**GREGORY CANYON LANDFILL JOINT
TECHNICAL DOCUMENT AND SOLID
WASTE FACILITY PERMIT
APPLICATION REVIEW –
TITLE 27 COMPLIANCE**

County of San Diego
Department of Environmental Health
Local Enforcement Agency
5500 Overland Ave, Suite 110 MS O560
San Diego, CA 92123

December 20, 2010

FIGURE 1

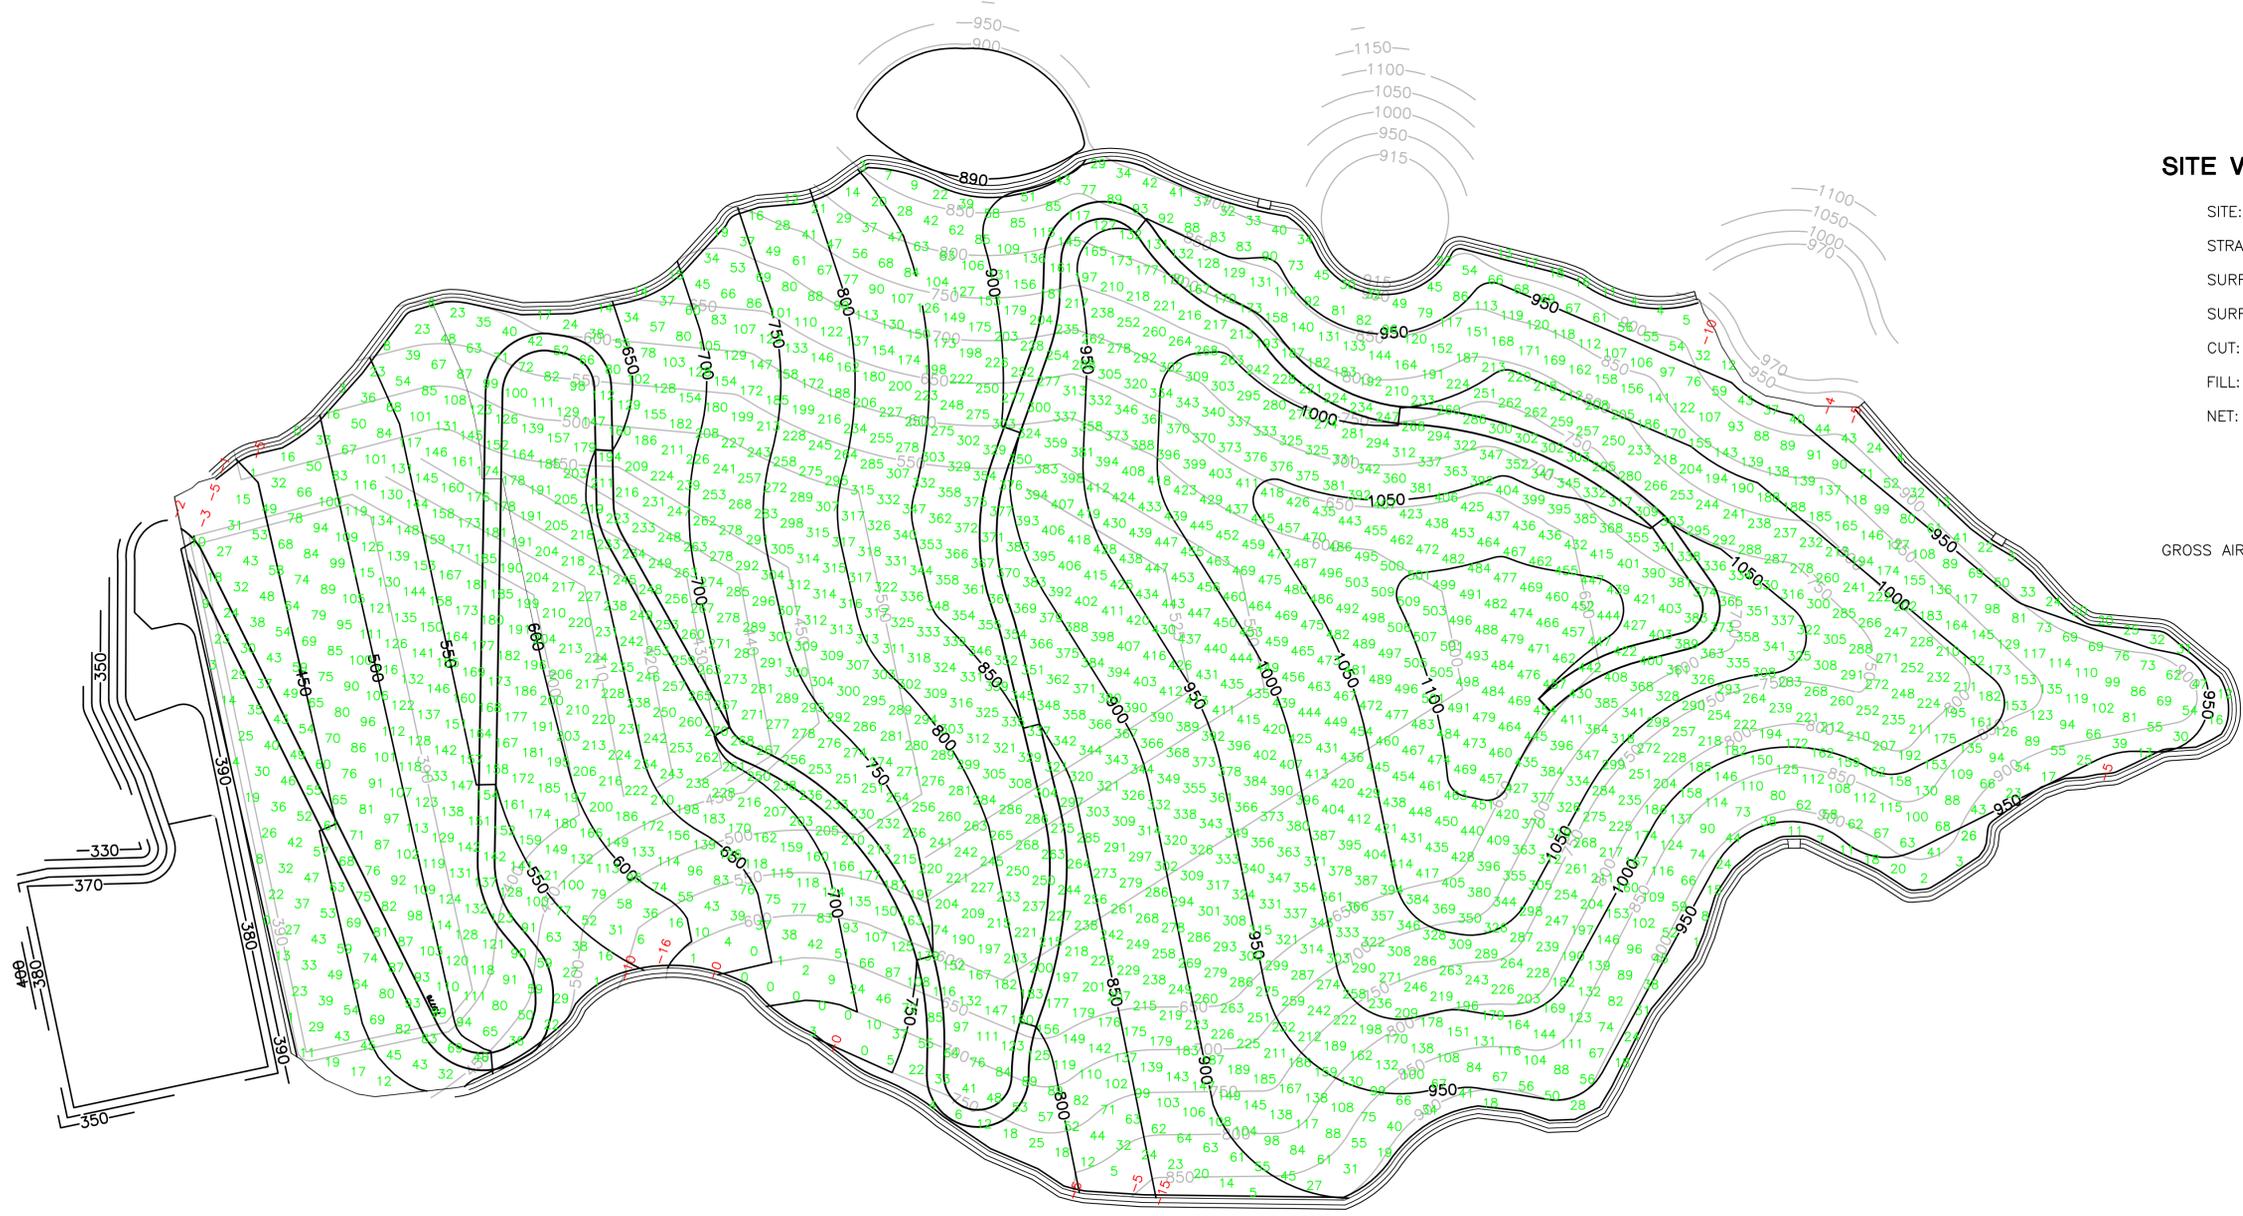
At the request of DEH, URS evaluated the airspace volume estimate included in the JTD. URS recreated the excavation and final grade surfaces using AutoCAD Land Development Desktop software and the AutoCad data generated by the applicant. Figure 1 provides the airspace volume estimate developed by the applicant and Figure 2 shows the airspace volume estimate developed by URS. As shown on the figures, the difference in the net airspace estimates vary by only 0.3% and both estimates are approximately 60,000,000 cubic yards.
